Los Angeles County  
Department of Regional Planning

SUBJECT: "REVISED PROJECT DESCRIPTION"  
THE CLEARMAN'S VILLAGE PROJECT  
LOS ANGELES COUNTY PROJECT NUMBER 03-147  
STATE CLEARINGHOUSE NO. 2003111123

## **REVISED PROJECT DESCRIPTION**

**COUNTY PROJECT NO. 03-147**  
**CONDITIONAL USE PERMIT NO. 03-147**  
**ZONING CHANGE NO. 03-147**  
**STATE CLEARINGHOUSE NO. 2003111123**

# EXHIBIT 2 REVISED PROJECT SITE PLAN

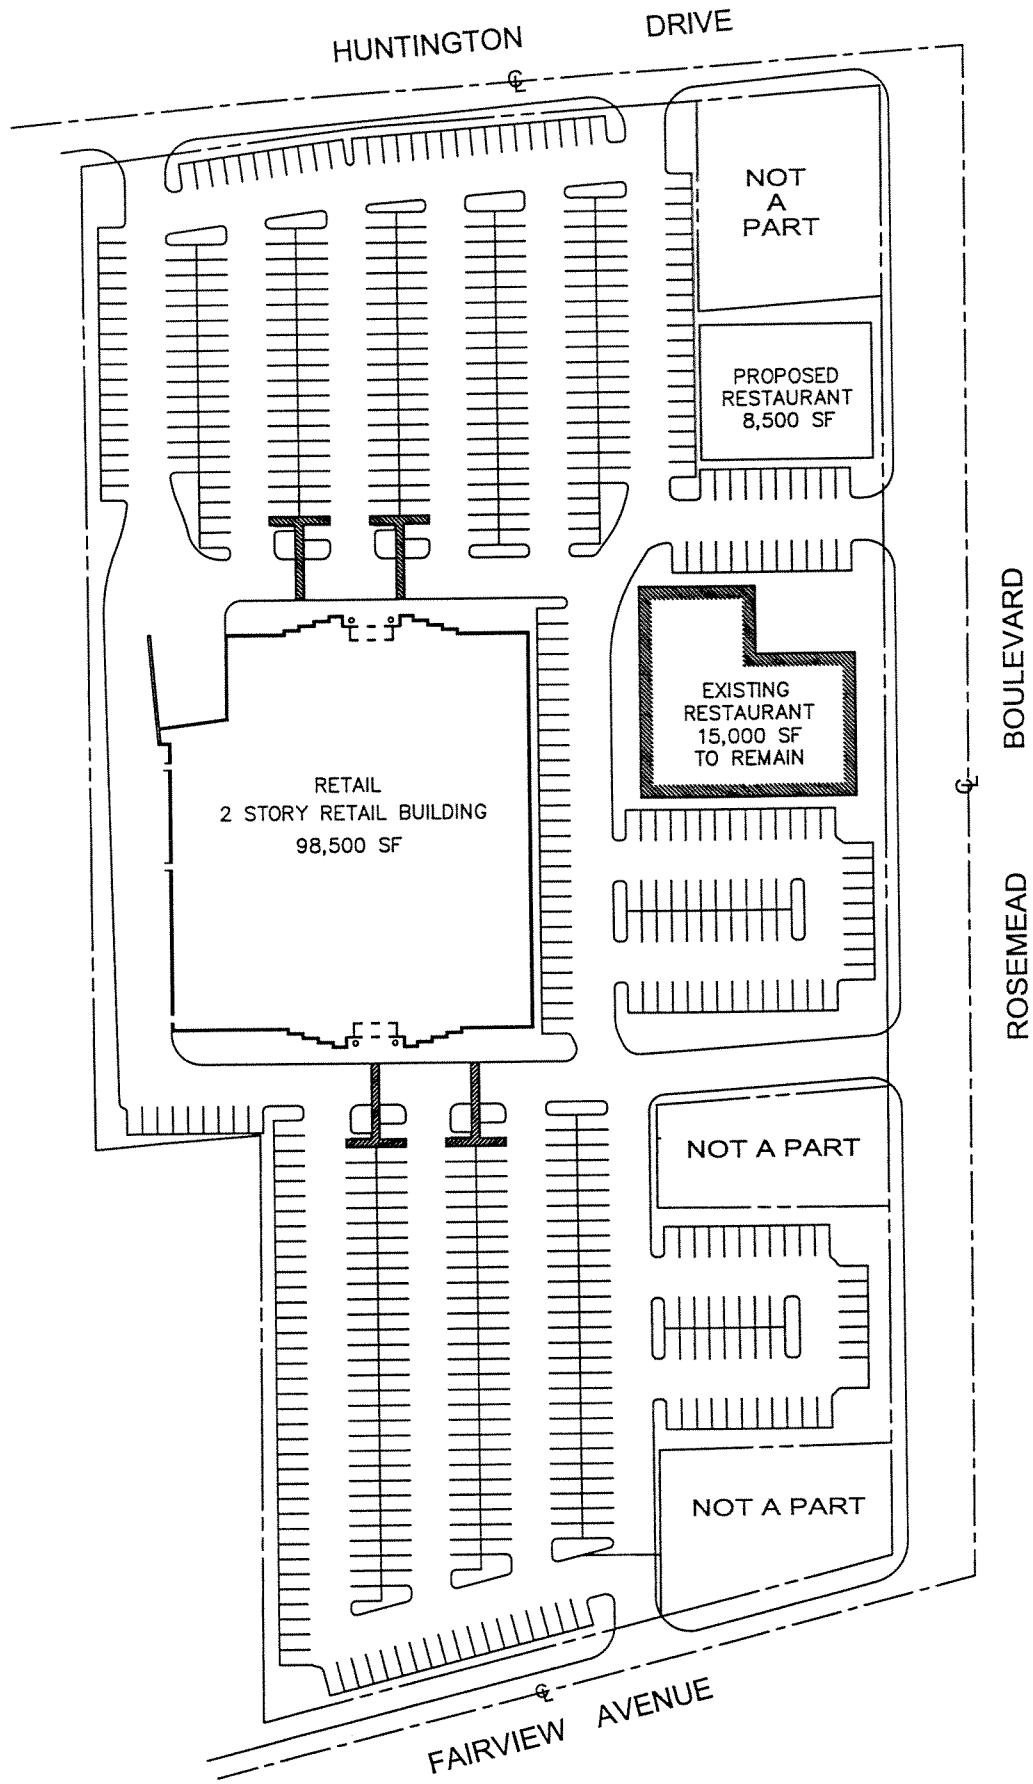
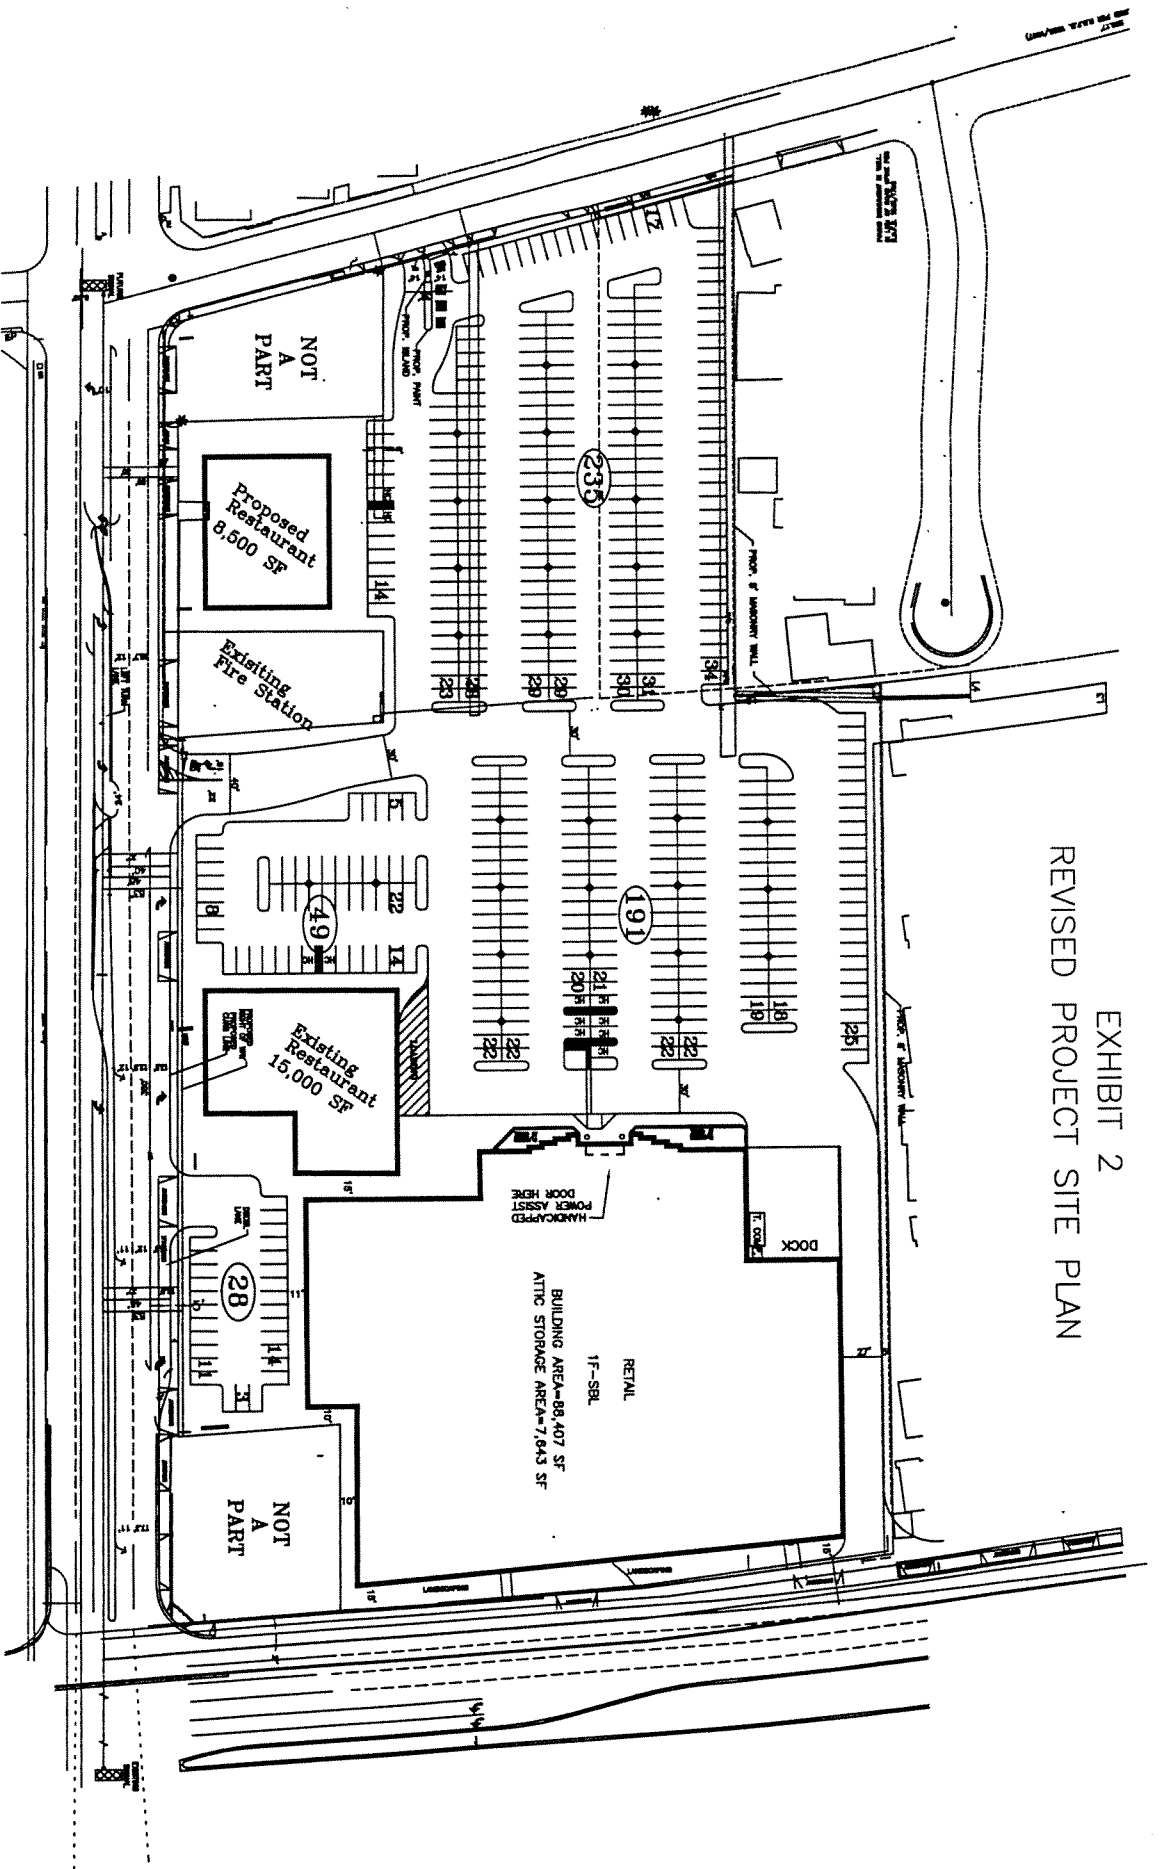
With the community issues considered, the Applicant has redesigned the project. The main structure is now proposed to be located close to Huntington Drive and the proposed height reduced from 45 feet to approximately 30 feet. Associated roadway improvements and other proposed changes are described in the attached Revised Project Description. The Revised Project will be discussed at the June 29, 2005 continued Public Hearing.

The Revised Project includes the proposed construction of a new, one-story building of approximately 88,407 square feet for retail sales and associated surface parking. The new structure is proposed to be approximately 30 feet in height, consistent with the existing East Pasadena-San Gabriel Community Standards District. In addition, the existing Galley restaurant will be demolished and rebuilt in an alternate location on the Project Site immediately south of the existing Fire Station, in a new, approximately 8,500 square foot, one-story building similar to the Original Project. The existing Northwoods Inn restaurant, approximately 15,000 square feet in size, would remain on the Project Site. The Revised site plan is attached as **Exhibit 2: Revised Site Plan**. The Revised Site Plan shows the retail building to be relocated to the northern portion of the site, adjacent to Huntington Drive. A summary of the differences between the Original Project and the Revised Project is provided in **Exhibit 3: Parameters Matrix**.

Access to the Project Site under the Revised Project will be provided via one driveway along Huntington Drive (one less than under the Original Project), two driveways along Rosemead Boulevard, and one driveway along Fairview Avenue which would be open for public access. The location of the Huntington Drive driveway will be along the western property boundary and will have full access to the site and the primary parking area. This driveway will permit right-turn ingress and right-turn egress only. The northern driveway on Rosemead Boulevard will permit access only to a 22-space employee parking lot to be located just north of the Northwoods Inn with right-turn ingress and right-turn egress only. The southern driveway on Rosemead Boulevard will be located immediately north of the Fire Station and will permit full access to the site and the primary parking. This will be the primary access point to the site and will permit both right-turn and left-turn ingress but right-turn egress only. The proposed driveway along Fairview Avenue will be located along the southeastern property boundary, immediately adjacent to the existing development fronting Rosemead Boulevard. This driveway will provide full access to the site and the primary parking but will allow only right-turn ingress and left-turn egress. Access driveways along Rosemead Boulevard and Fairview Avenue will have physical barriers ('pork-chop' islands) to require the proposed directional ingress and egress. To aid in the overall circulation of traffic in the area and on the site, the Revised Project includes installation of a traffic signal at the intersection of Rosemead Boulevard and Fairview Avenue, the improvement of a deceleration lane on southbound Rosemead Boulevard south of Huntington Drive, as well as restriping and median modification to provide dual left-turn lanes on both northbound and southbound Rosemead Boulevard at Huntington Drive. Proposed lane configurations under the Revised Project are shown in **Exhibit 4: Lane Configurations with Revised Project and Project Mitigation**. Exhibit 4 shows area-wide project-related mitigation as well as those improvements proposed under the Revised Project. A new traffic analysis was prepared to analyze the Revised Project access scheme and improvement design. The conclusions of this revised analysis with respect to Level of Service at project-area study intersections are summarized in **Exhibit 5: Summary of Mitigated Project Volume to Capacity Ratios and Levels of Service AM and PM Peak Hours**. The new traffic analysis is available for review at the Department of Regional Planning.
